VALUE ENGINEERING REPORT

I-85 HOV to HOT Conversion Project
CSMSL-0009-00(295), (296), & (297)
PI No 0009295/0009296/0009297
DeKalb/Gwinnett Counties

October 8, 2009

Idea No.: C-2
 Client: GDOT
 Sheet 2 of 4

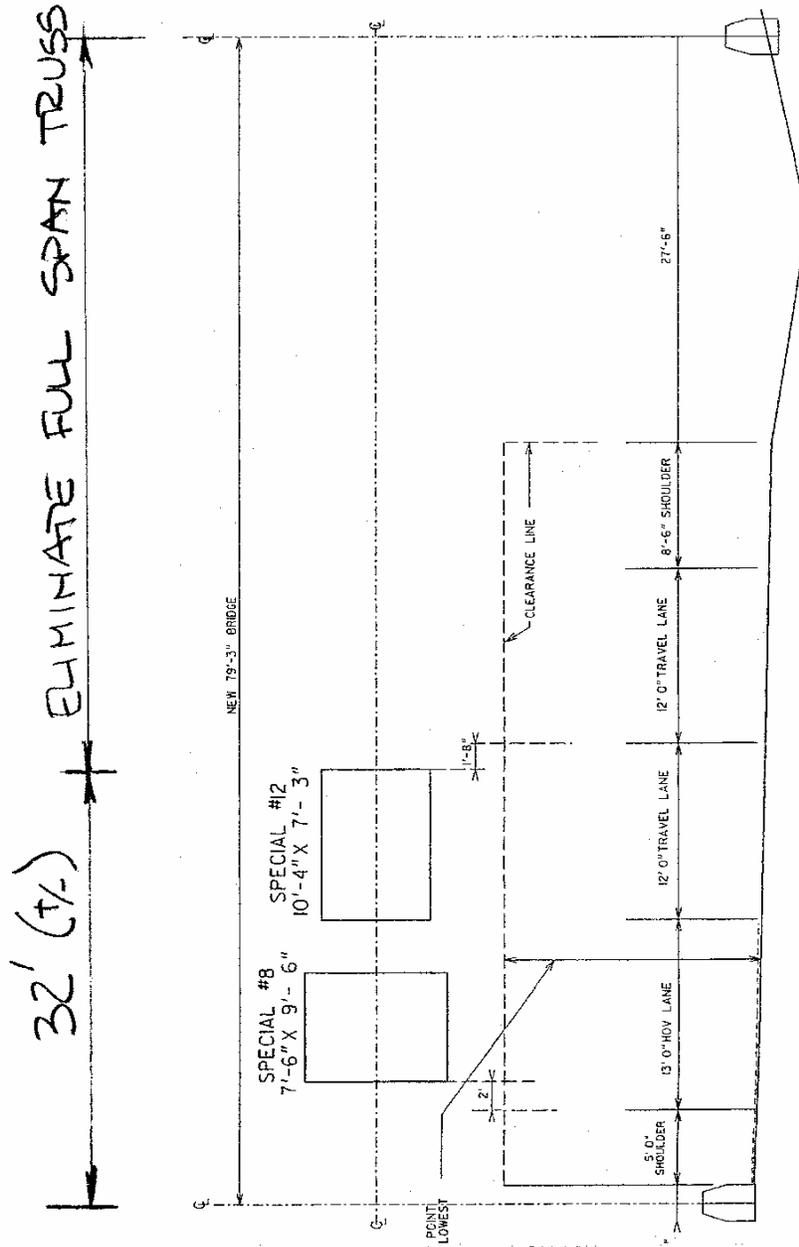
IDEA No.: C-2	Sheet No.: 1 of 4	CREATIVE IDEA: Use Type II or V, Cantaliver sign structures in-lieu-of overhead sign trusses for regular signing at six locations.
-------------------------	-----------------------------	--

The current plans use full-span structures (Type I) for smaller signs placed over the left side lanes

At 6 locations, not including the variable display signs, full span Type I structures are proposed to support relatively small overhead signs over the left lanes. The current plans already include Type II or V, Cantaliver sign structures with arm spans of over 40 feet.

Idea No.: D-4
Client: GDOT
Sheet 2 of 3

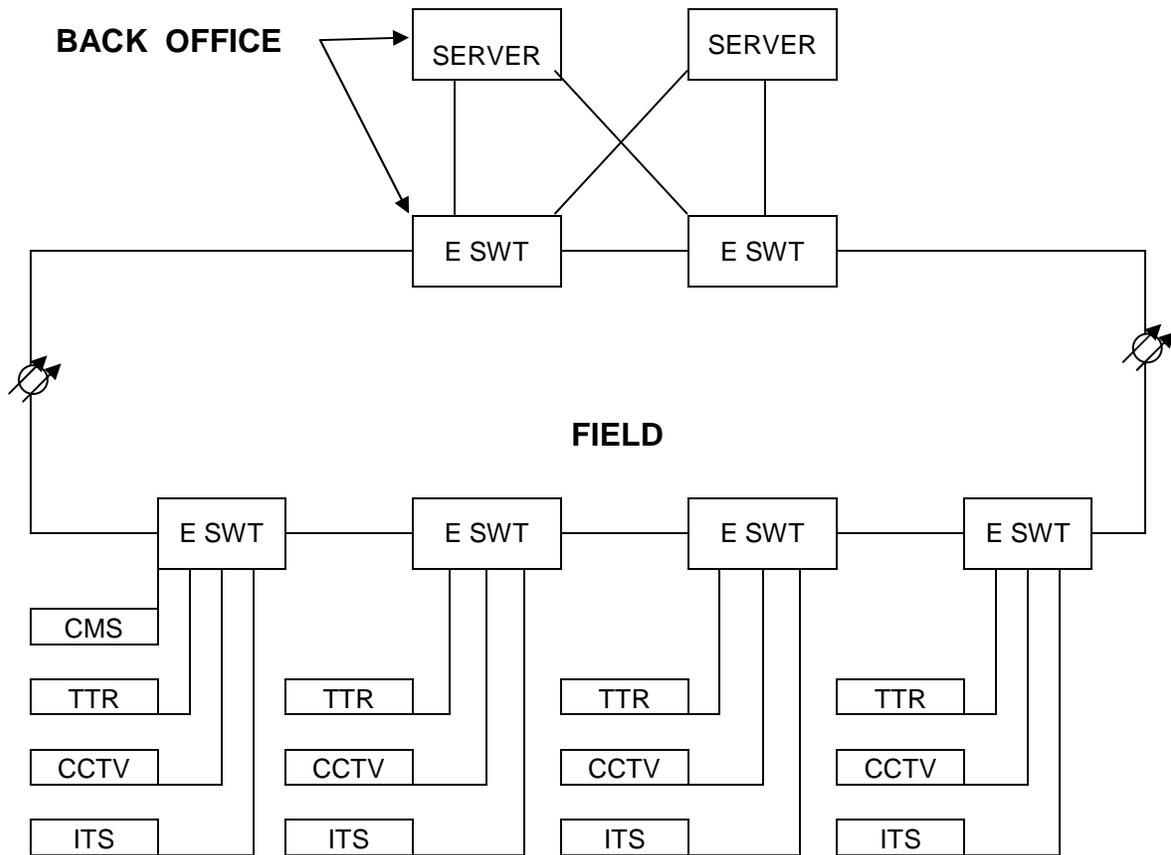
IDEA No.: D-4	Sheet No.: 1 of 3	CREATIVE IDEA: Reduce the size of the fiber optic cable from 72 strands to 36 strands or less.
-------------------------	-----------------------------	--

The field Ethernet network requires only four fibers for Ring Network and drop cables to operate the HOT electronics. The 72 count fiber cable appears excessive unless additional equipment is planned to be installed that will use the excess capacity or the extra capacity is needed for some future use.

NOTE: Can use wave division multiplexing (1310/1550 nm) to reduce fiber from 2 to 1.

Sheet 2 of 3

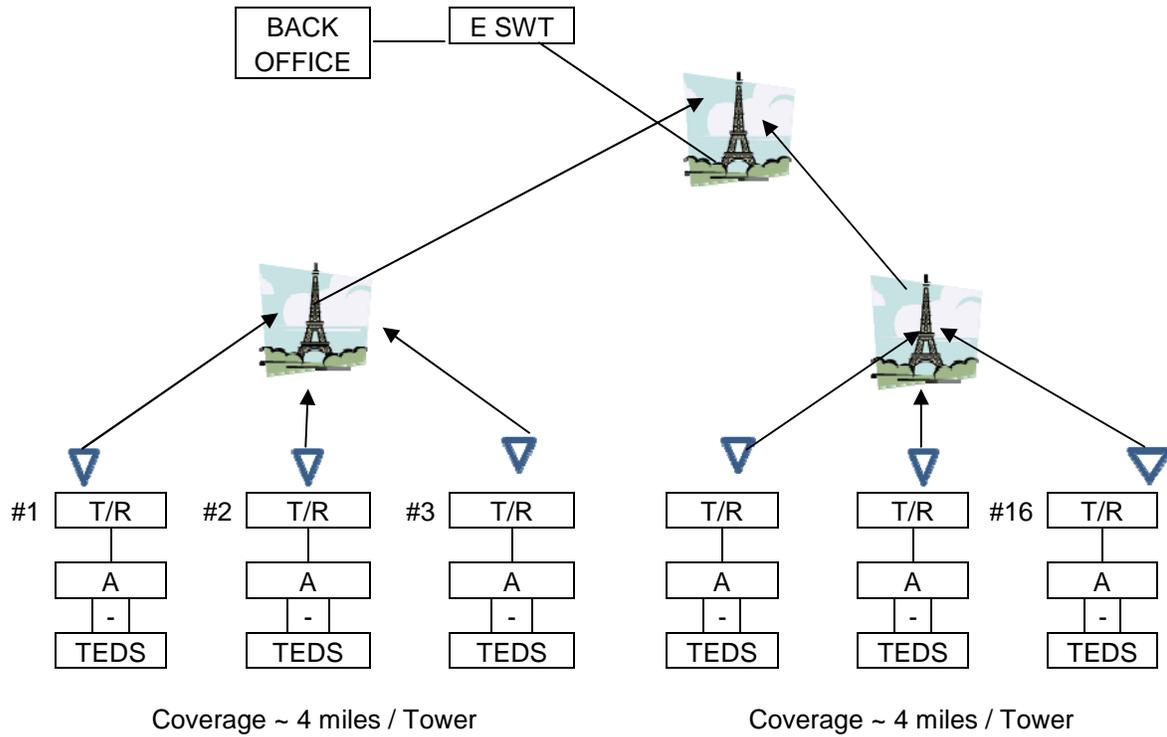
IDEA No.: D-16	Sheet No.: 1 of 3	CREATIVE IDEA: Construct a wireless communication network in-lieu-of hard wired communication network to support the HOT system.
--------------------------	-----------------------------	--

The construction of a wireless field Ethernet system would save installation time and reduce the cost of the system. Continuing the use of the wireless concept on future HOT lane segments would result in addition time and cost savings.

Idea No.: F-1
Client: GDOT
Sheet 2 of 4

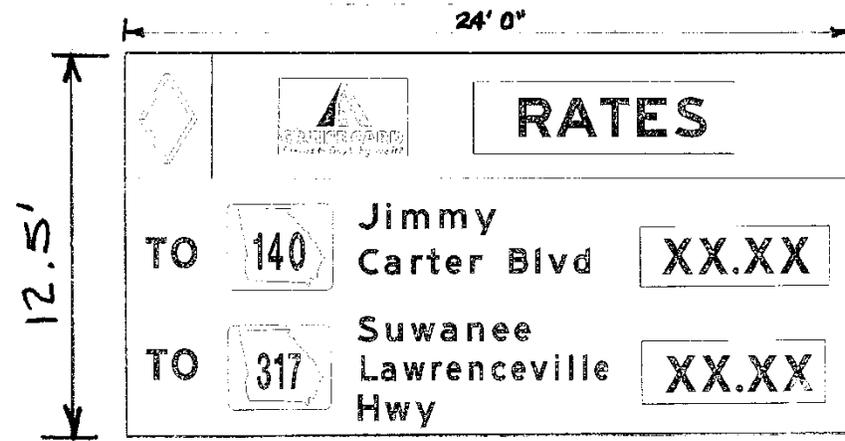
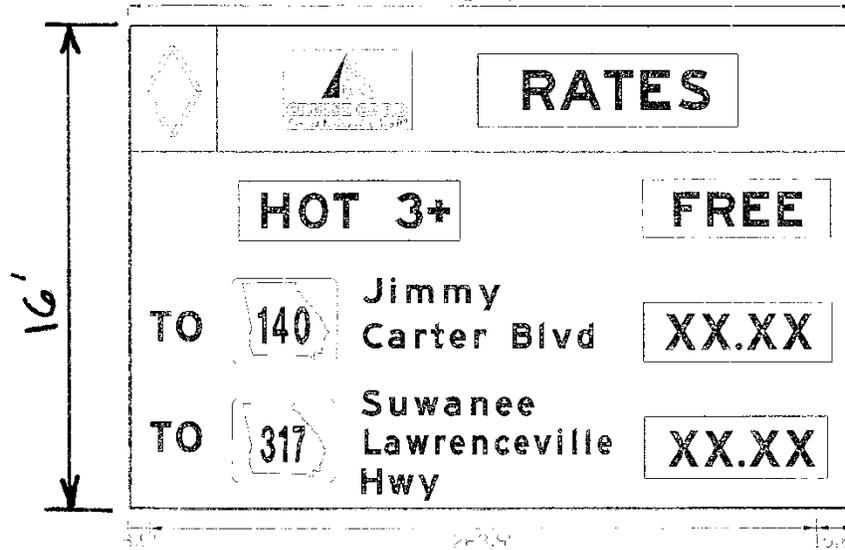
IDEA No.: F-1	Sheet No.: 1 of 4	CREATIVE IDEA: Eliminate the word/line "HOT 3+ Free" from the changeable message sign.
-------------------------	-----------------------------	--

Idea No.: H-1
Client: GDOT
Sheet 2 of 3

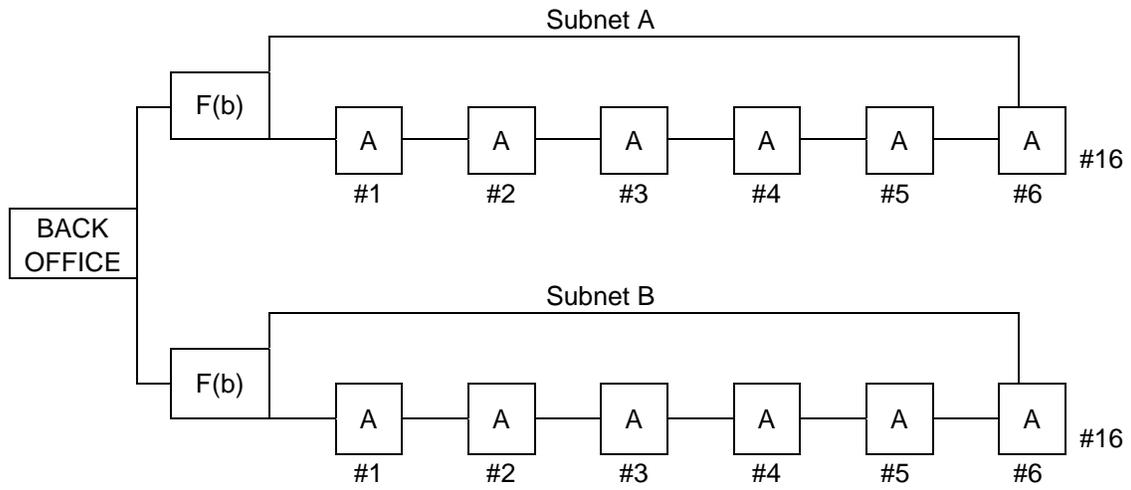
IDEA No.: H-1	Sheet No.: 1 of 3	CREATIVE IDEA: Use the proper size (ports/features) and number of Ethernet switches.
-------------------------	-----------------------------	--

The large Type F(a) Ethernet switches are usually only used in the "back office." The current plans did not indicate how the F(a) and F6 switches are being used.

Assumed Architecture Since None Provided
